Title		
Insp_Eng_8_Pack_Cntlr		
Size	Document Number	Rev
C	10020932_8	B
Date:	Monday, December 23, 2013	Sheet 1 of 1

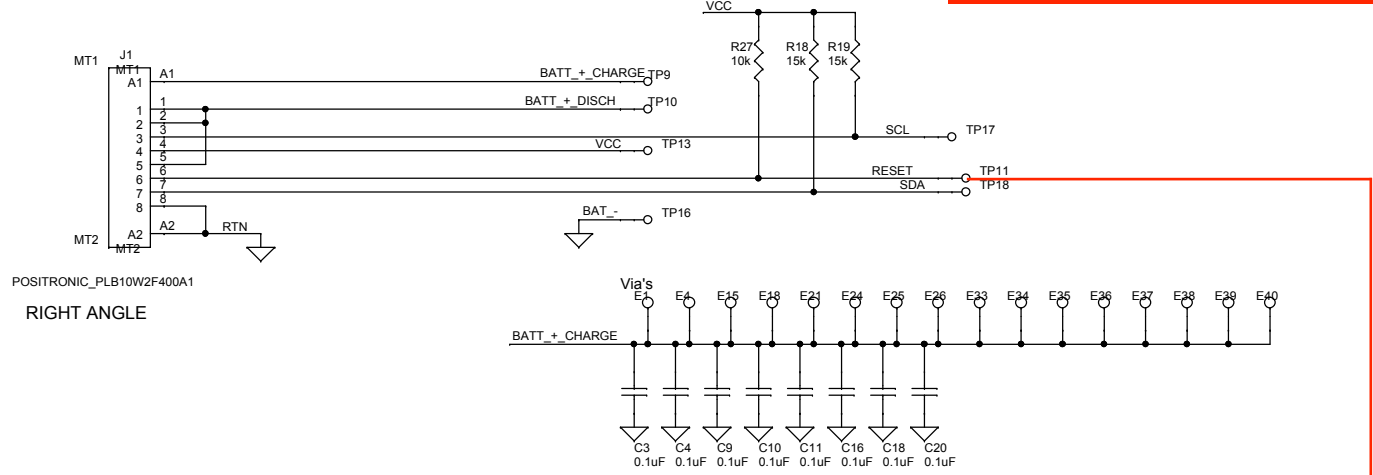
LIFT GULL WING ON PIN 3 U4

Removed LT3080 Voltage Regulator and associated components: 12 Sept 13 drt

Set mux address to 7 hex: 11 Nov 13 drt
